**RESCINDED
JANUARY 2024**
This Recommended
Change to the MUTCD
was rescinded by the
NCUTCD Council on
January 12, 2024.

**National Committee on Uniform Traffic Control Devices
GMI SIGNS TECHNICAL COMMITTEE RECOMMENDATION**

TOPIC: GUIDE SIGNS FOR OPTION LANES

AFFECTED PORTIONS OF MUTCD: Chapters 2D and 2E, Sections 2D.08, 2E.19 through 2E.23, 2E.32, 2E.33, 2E. 36, 2E.44

432 Change Figure Title to: Example of Alternative Sign Series for a Two Lane Exit with
RESCINDED JANUARY 2024 an Option Lane – Arrow-per-Lane style

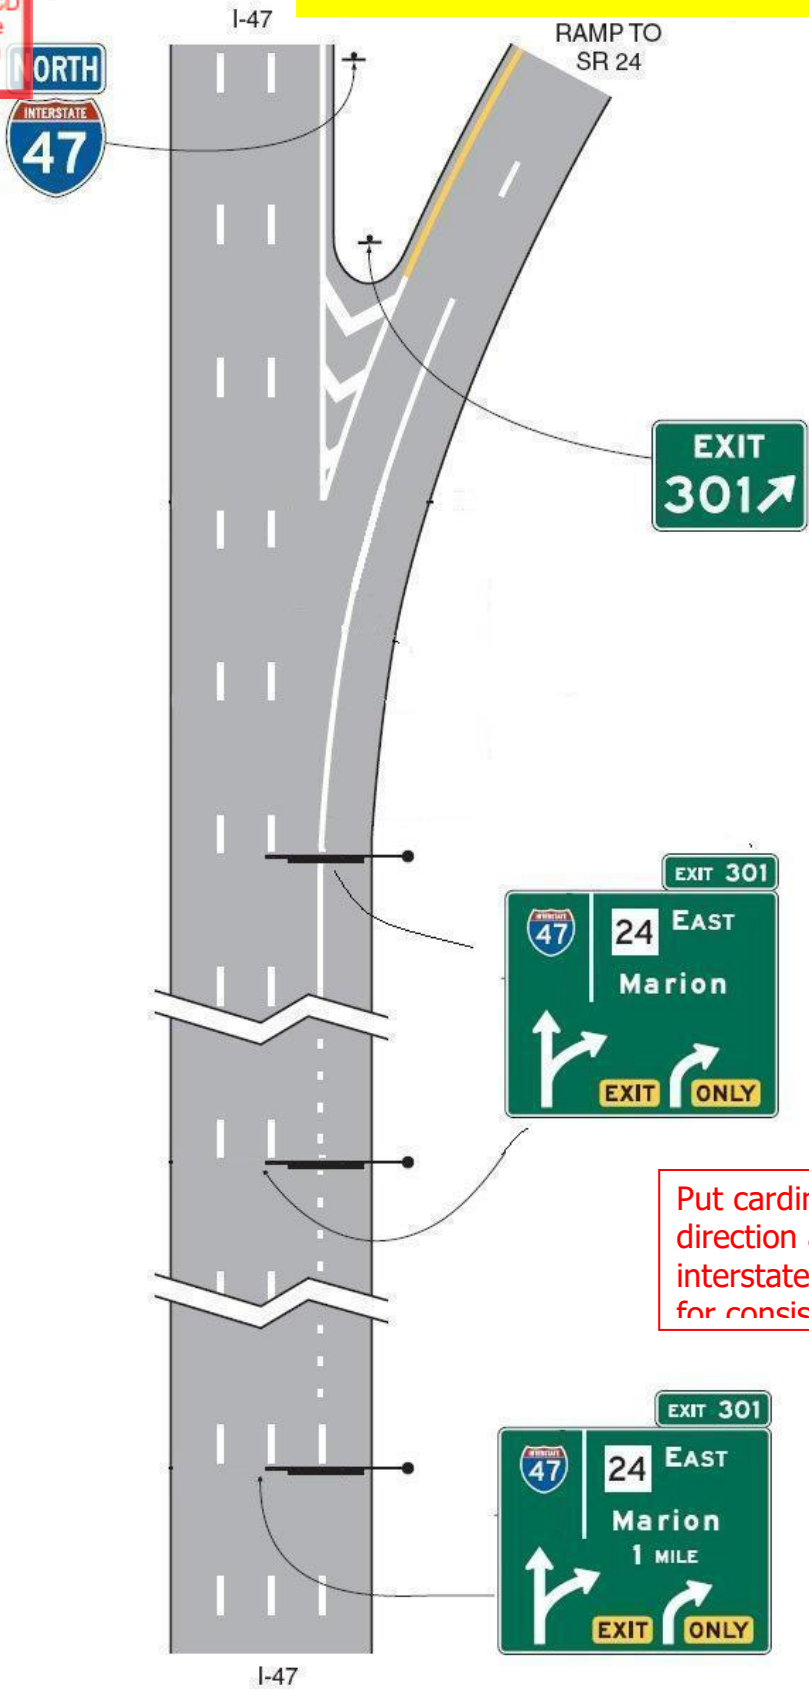
As an alternative to the Overhead Arrow-per-Lane or Diagrammatic guide signs described in Section 2E.20, either of the alternate sign series shown in Figures 2E-I or 2E-J may be used on freeways and expressways for multi-lane exits at interchanges that have an optional exit lane that also carries the through route.

When used, the sign designs illustrated in Figure 2E-I shall include one arrow above each exiting lane and one arrow above each option lane and the shaft of each arrow shall be located approximately over the center of the lane to which it applies.

Figure 2E-124 Example of Signing for a Two-Lane Intermediate or Minor Interchange Exit with Option and Auxiliary Lanes

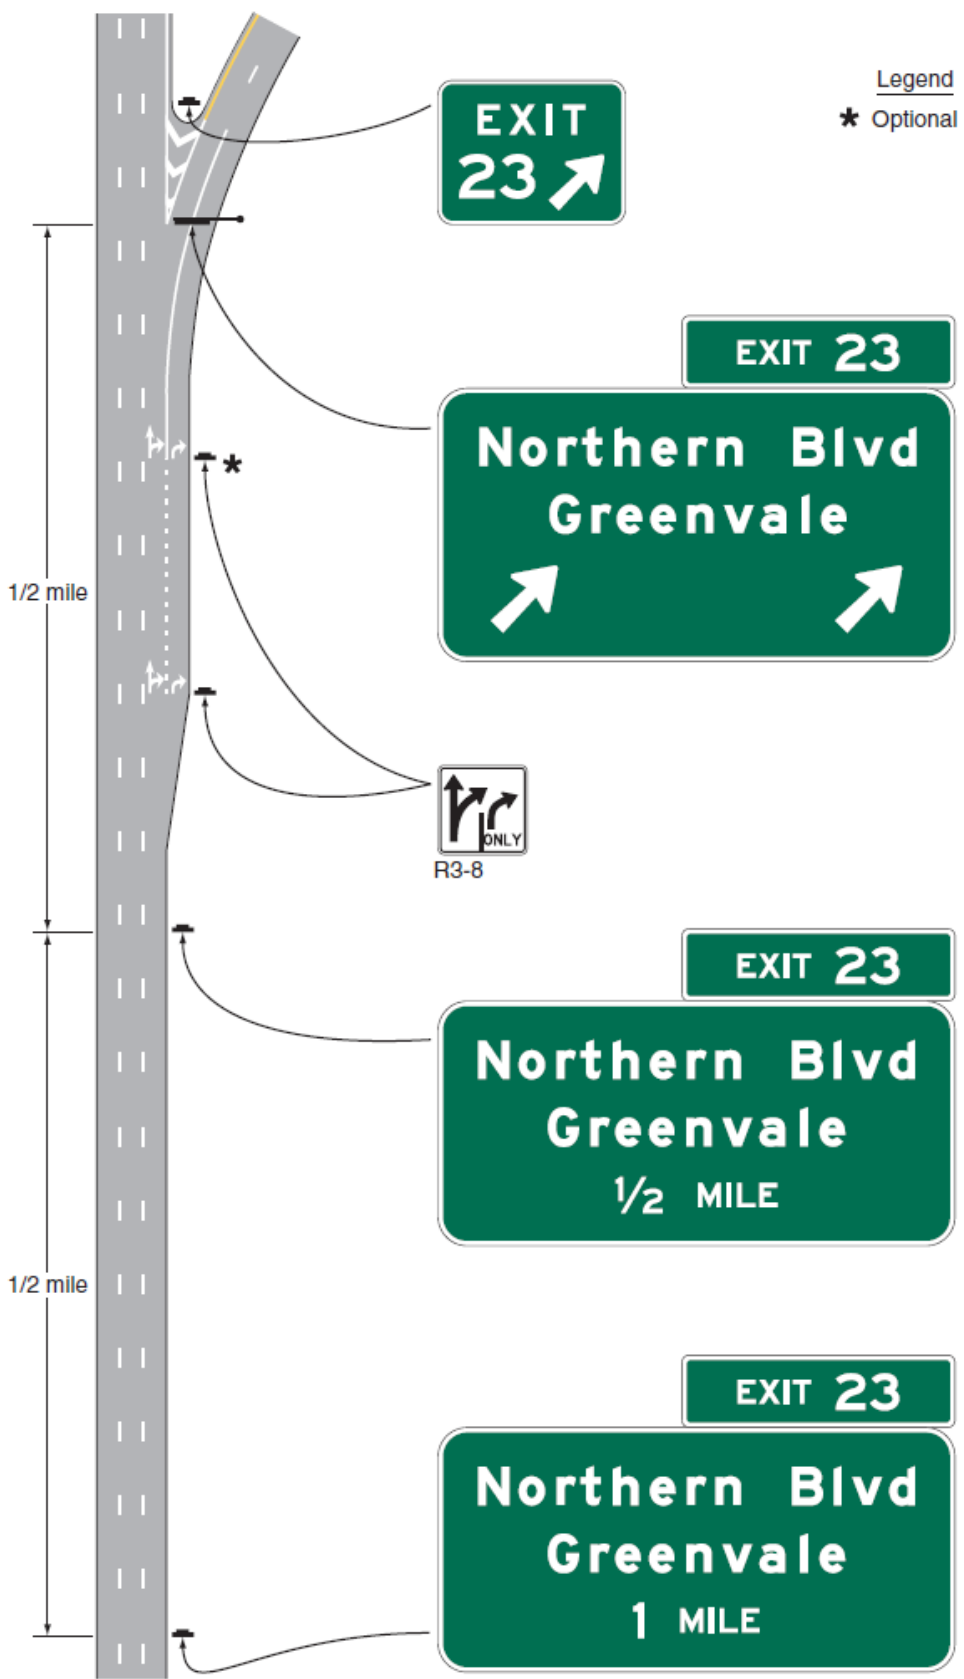
591 Existing Figure 2E-124 to be deleted
592 RESCINDED
593 JANUARY 2024
594
595 This Recommended
596 Change to the MUTCD
597 was rescinded by the
598 NCUTCD Council on
599 January 12, 2024.

643 Existing Figure 2E-112 to be deleted
 644 Figure 2E-112. Example of Signing for a Two-Lane Intermediate or Minor
 645 interchange

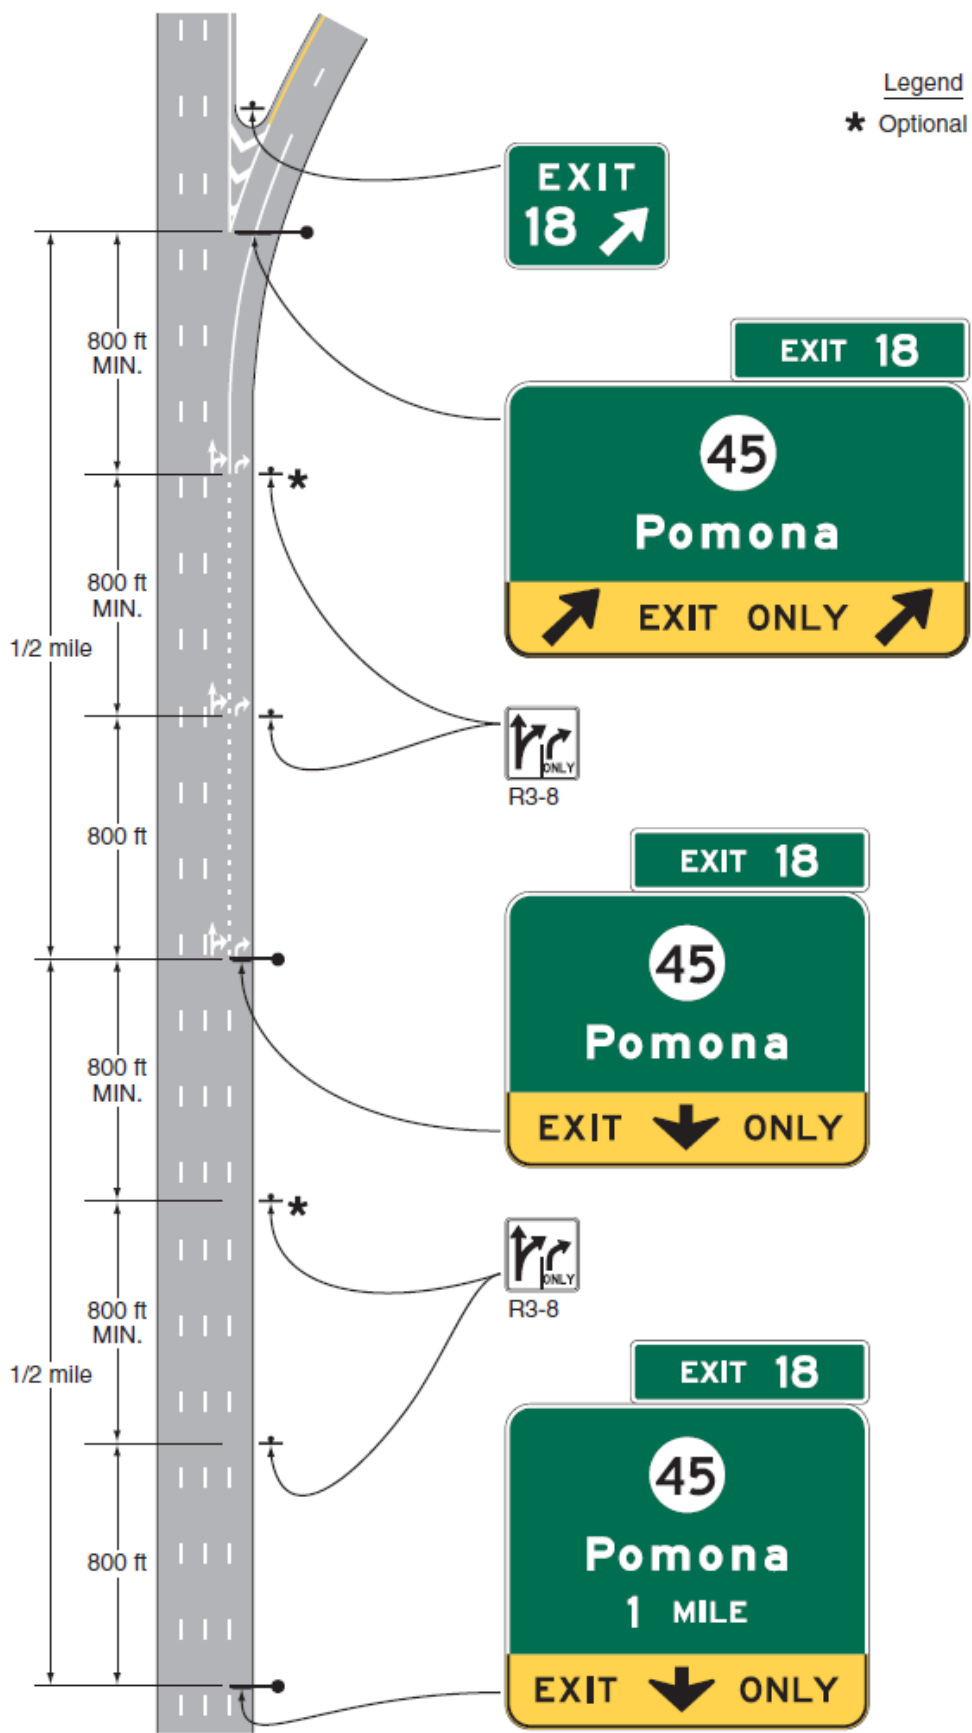
643 Existing Figure 2E-112 to be deleted
 644 RESCINDED Figure 2E-112
 645 JANUARY 2024
 646 This Recommended
 647 Change to the MUTCD
 648 was rescinded by the
 649 NCUTCD Council on
 650 January 12, 2024.
